**MAJOR PROJECT ASSESSMENT:**

***Adaptive Reuse of the Clare Hotel and  
Administration Building on Block 3A***

***Central Park, Chippendale  
(Former Carlton United Brewery)  
MP11\_0089***

Director-General's  
Environmental Assessment Report  
Section 75I of the  
*Environmental Planning and Assessment Act 1979*

**Figure 2 - East Elevation with increased setback above the Clare Hotel (source: Proponent's RtS)**  
*Clouding of the East Elevation illustrates the increased setback of the additional level on the Clare Hotel*

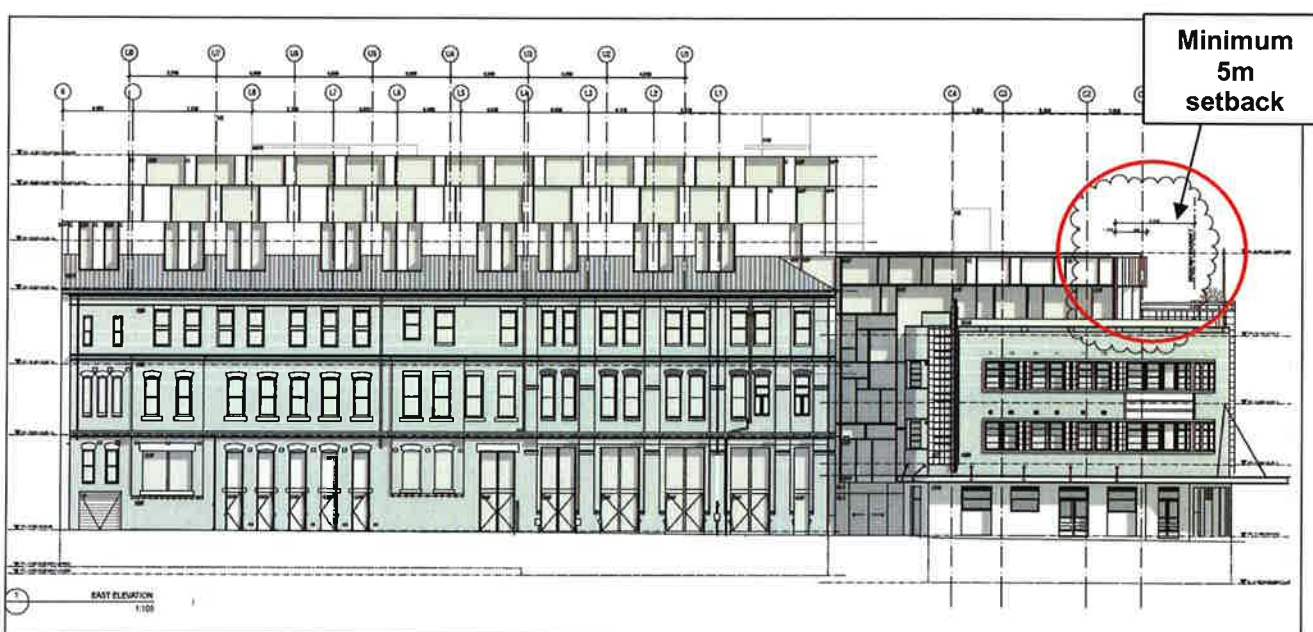
- Generally considers height breaches to the Concept Plan acceptable subject to further detail demonstrating the proposal will not have adverse impacts when viewed from Carlton Street;
- Recommends the additional floor above the Clare Hotel be set back a minimum of 5 metres from the northern boundary of the site;
- Noted that there is no capacity to conserve the executive passenger lift and enclosure in the design and construction methodology;
- Recommends adequate recording of significant interior spaces prior to dismantling the passenger lift and enclosure and that a protection and construction methodology be developed and submitted to Council; and
- The link between the Clare Hotel and Administration Building is not consistent with Concept Plan approval however is considered generally acceptable.

On 22 February 2013, the Department wrote to the Proponent outlining a number of key issues, requesting additional information and a response to all submissions received. On 5 March, 2013 the Proponent provided a response to the issues raised in submissions and issues raised by the Department (see **Appendix B**). The RtS made modifications to the project including the provision of a minimum 5 metre setback to the addition on the north elevation of the Clare Hotel.

On 5 March 2013 the Proponent submitted a Response to Submissions which amended the Project to increase the setback of the additional level above the Clare Hotel from the northern boundary to a minimum of 5 metres.

In the Proponent's RtS, the design was modified to incorporate the requested minimum 5 metre setback for the single storey addition. On this basis, the Department is satisfied that the proposal will protect and preserve existing significant features and supports the adaptive reuse of the Clare Hotel. In addition the Department considers the Project to be appropriate in terms of visual bulk, particularly given the increased setback above the Clare Hotel.

**Figure 3 - Section through the Administration Building showing approved height in red**

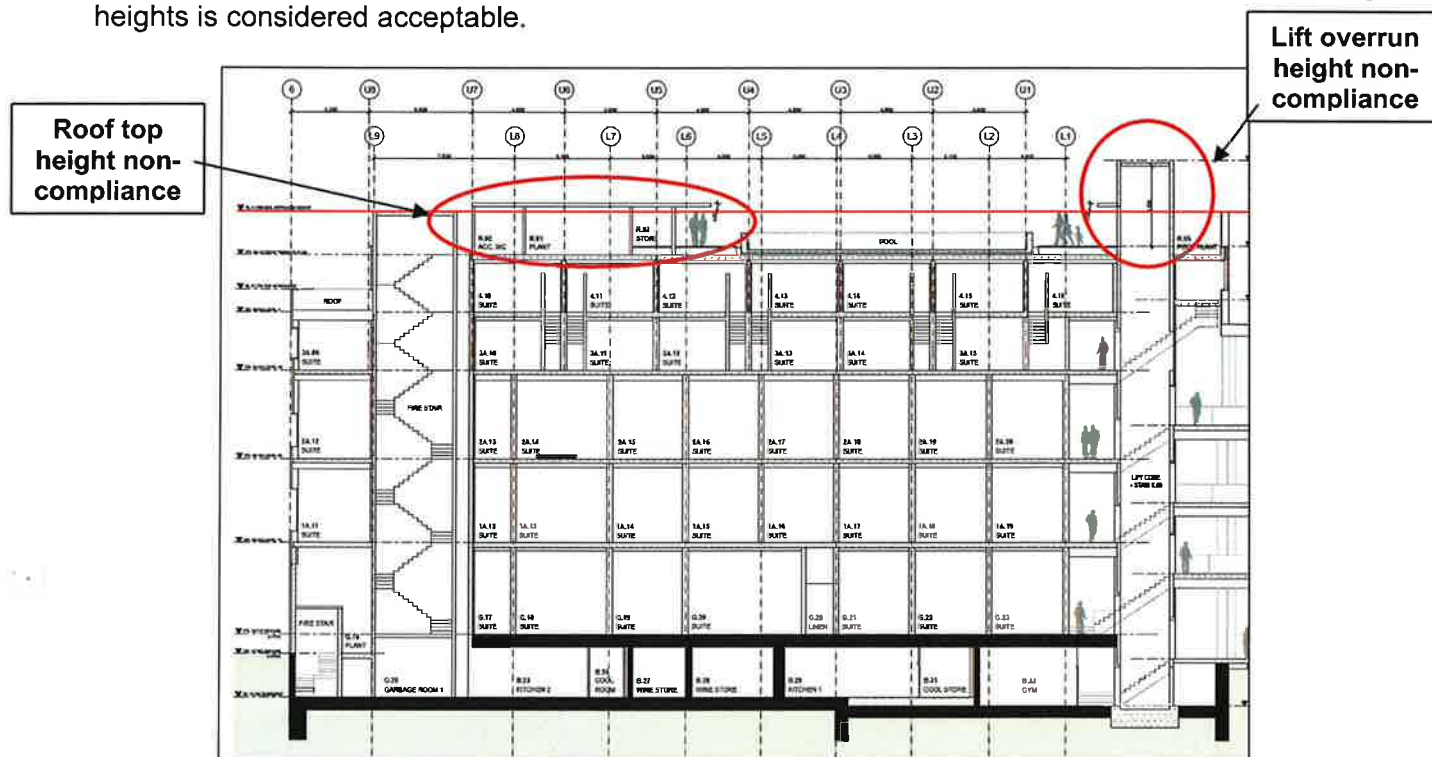
complies with the Concept Plan approval. However, as **Table 2** illustrates the proposed building heights do not comply with the overall maximum building heights required by the approved Concept Plan.

There are two elements of the proposed building that do not comply with the overall building height which are: the lift overrun and the roof top over the WC, plant room and pool side bar. The non-compliance can be seen in **Figures 3 and 4** below.

The non-compliance caused by the proposed lift overrun will project 2.7m above the maximum RL approved by the Concept Plan. This non-compliance is required to accommodate equitable access to the roof level. Only one lift will provide access to roof level and it is set back from the edge of the approved envelope to mitigate visual impact from the public domain. Given that the lift overrun does not significantly increase visual bulk or overshadowing, the variance to approved building heights is considered acceptable.

Figure 4 - Concept Plan envelope analysis view from north-west. Source: Proponent's EA

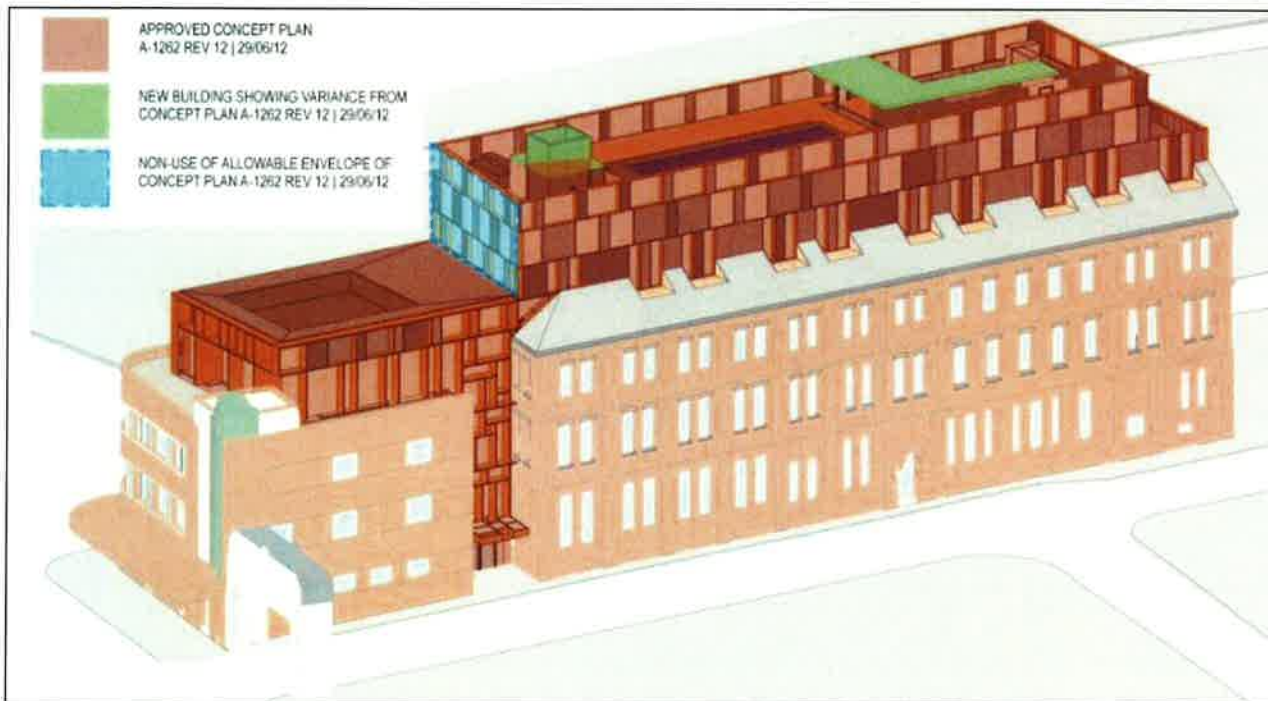
The rooftop over the accessible WC, the electrical plant area and the poolside bar, project 400mm higher than the maximum building height approved by the Concept Plan. This non-compliance with the Concept Plan is to accommodate the heritage conservation measures required for the Heritage Boardroom Suite on Level 2, while retaining the minimum floor to ceiling heights on the floors above.

At the request of the Department, the Proponent submitted additional photomontages from Carlton Street (**Figure 5**). These demonstrate that the height of the rooftop features which will exceed the Concept Plan's approved maximum heights will only be marginally discernable from the surrounding public domain. The area of non-compliance is minor and will not significantly alter the appearance of the building. Accordingly, the proposed height is considered acceptable.
